**CITY OF TEMPE
DEVELOPMENT REVIEW COMMISSION**

**Meeting Date: 07/09/2019
Agenda Item: 11**

ACTION: Request a Use Permit Standard to reduce the rear building setback from 15 feet to 12 feet and a Development Plan Review consisting of four new attached single-family dwelling units for HAMMOND RESIDENCES, located at 2051 South Hammond Drive. The applicant is Tonnesen, Inc.

HAMMOND RESIDENCES (PL190113)

SHEET
 18" x 11" 1/4"
SITE PLAN
 NUMBER
A100

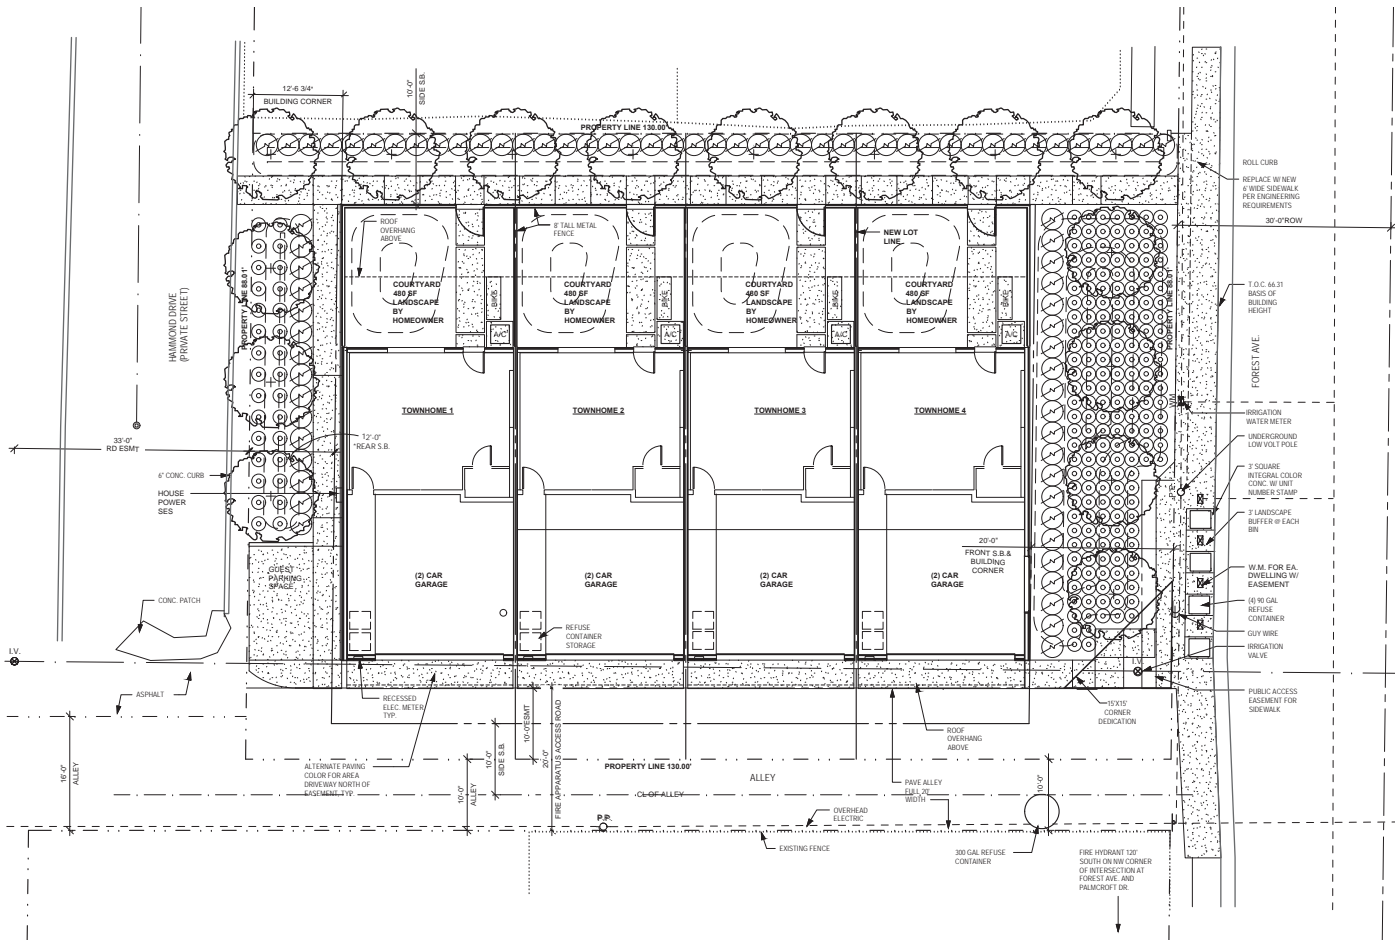
May 29, 2019 - First Formal Site Plan Review provided the required documents for full review. Staff referred to the Character Area Plan. With regard to the site plan, the applicant addressed all of staff's comments/questions/corrections.

The building is oriented with the long elevations to the north and south and short ends facing east and west to the streets. The private courtyards are on the north side of the site and are screened by 8' galvanized corrugated steel fencing with gates of matching heights. The 480 s.f. courtyard has almost a 50% shade canopy from the projection of the building above on the second floor. Bike storage and the air condition unit are provided in this sheltered space next to the unit entrances. A 10' setback outside of the courtyard provides a sidewalk connecting to the street front and common landscape area with trees. Garages are accessed from the alley to the south, which face an existing 10' alley and 10' access easement to create a 20' wide alley. An additional 3'11" is provided at the entrance to the garage to meet the backing distance requirements for vehicle circulation. An existing irrigation valve and underline private irrigation line are located on the property. Water Utilities notified the applicant that flood irrigation lines must be maintained by land owner for downstream users. A minimum of 5' of separation should be maintained between irrigation line and structures, the plans indicate the south building wall is closer than 5'. The condition of this line is unknown and may need to be rehabilitated to ensure continuity of service and to protect new building structures from structural damage should leaks occur. A condition has been added to address this. The east side provides a new 6' public sidewalk and a sidewalk wrap to accommodate accessible travel on trash collection days without impacting pedestrians. Each unit has a designated pad for the recycle/refuse bin and storage is in the garage on non-collection days. A sidewalk runs along the west side of the building to provide access from the guest parking on site. The setback on the west side is 12' as described in the use permit standard request for reduction. The unit orientation is designed to maximize energy efficiency on site with first floor uses buffered by the garage on the ground floor south side and shaded by the upper floor on the north side.

4. Provide service yard and mechanical yard walls that are at least 8'-0" tall as measured from adjacent grade and are at least the height of the equipment being enclosed, whichever is greater. Verify height of equipment and mounting base to ensure that wall height is adequate to fully screen the equipment.
5. Provide gates of steel vertical picket, steel mesh, steel panel or similar construction. Where a gate has a screen function and is completely opaque, provide vision portals for visual surveillance. Provide gates of height that match that of the adjacent enclosure walls. Review gate hardware with Building Safety and Fire staff and design gate to resolve lock and emergency ingress/egress features that may be required.
6. Provide upgraded paving at each garage entrance drive consisting of integral colored concrete. Extend this paving in

the driveway from the edge of the 10' easement to the face of the garage door to clearly delineate the 20' alleyway from the garage driveway of the units.

1 UTILITY & LIGHTING PLAN
1/8" = 1'-0"

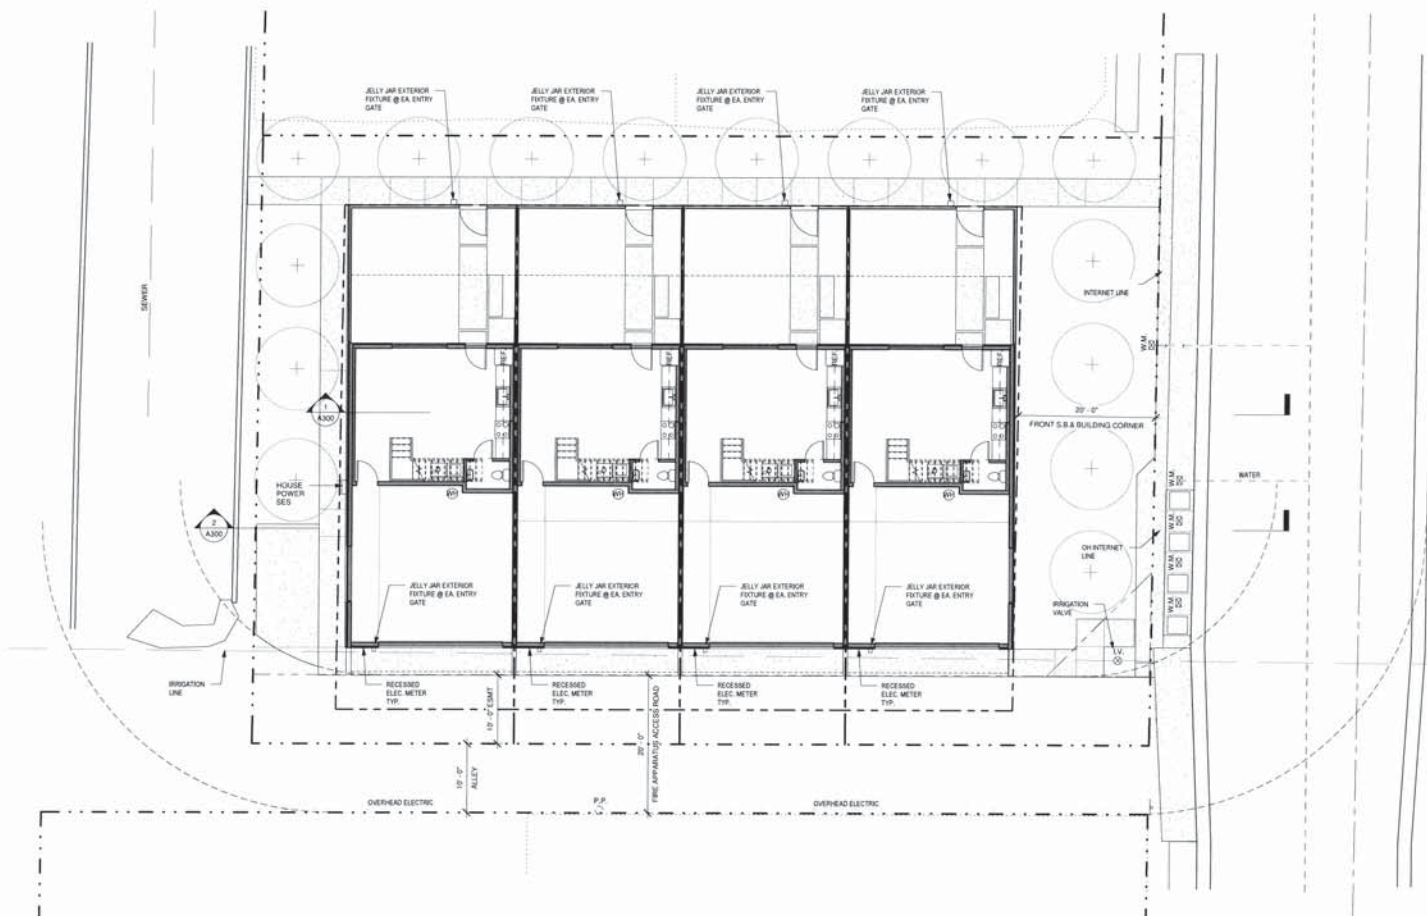
12. *Lighting is compatible with the proposed building(s) and adjoining buildings and uses and does not create negative effects. Mason Jar fixtures were added to the south side elevations to provide light at the garage doors. Other lighting elements will be reviewed during plan check of construction documents. A condition was added to mitigate glare from lights to the residences to the south.*

15. This project shall follow requirements of ZDC Part 4, Chapter 8, Lighting, unless otherwise conditioned.
16. Provide light shields on fixtures facing south to prevent light trespass to residences to the south.
17. Illuminate building garage entrances from dusk to dawn to assist with visual surveillance at these locations.
